## MANDATORY SERVICE LETTER

SL-200C/400C-0002

**TO:** ALL OWNERS / OPERATORS OF AFFECTED PROPELLERS  
**SUBJECT:** MANDATORY BLADE FERRULE ROOT MODIFICATION  
**DATE:** FEBRUARY 4, 2003

## 200C / 400C SERIES PROPELLER SL-200C-400C-0002 FASTENER INSTRUCTIONS

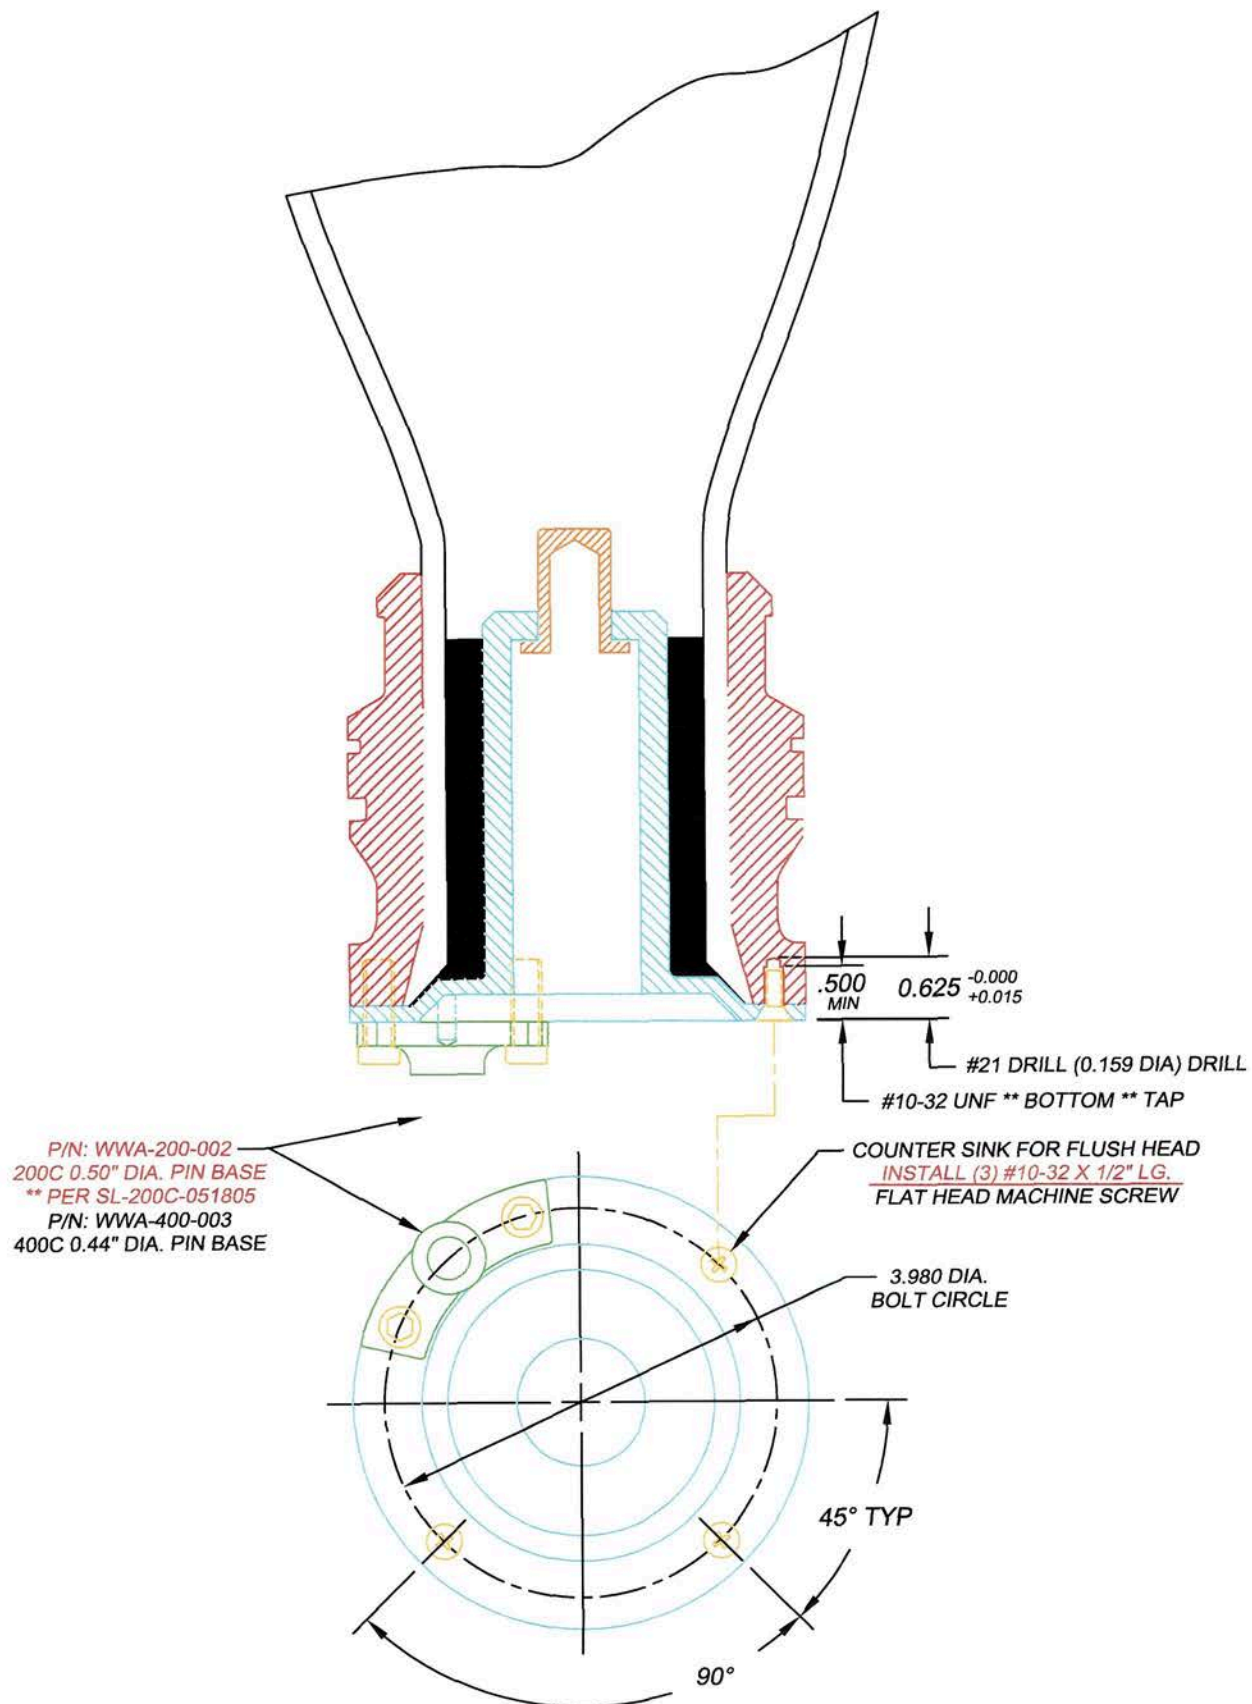
**REASON:** Blade root inner ferrule may slip resulting in loss of pitch control in affected propeller models.

1. A blade ferrule root modification must be performed for all affected propeller models. This modification will require the affected propeller models to be disassembled for the removal of the blades. The blade modification requires three #10 fasteners to be installed at the ferrule root of each blade. After the blade modification is complete, the propeller can then be reassembled and returned to regular service.
2. This modification can be performed by the Whirl Wind Propellers factory. Alternatively, a modification kit will be provided to a qualified propeller service center to perform this modification per Whirl Wind drawing upon approval by Whirl Wind.
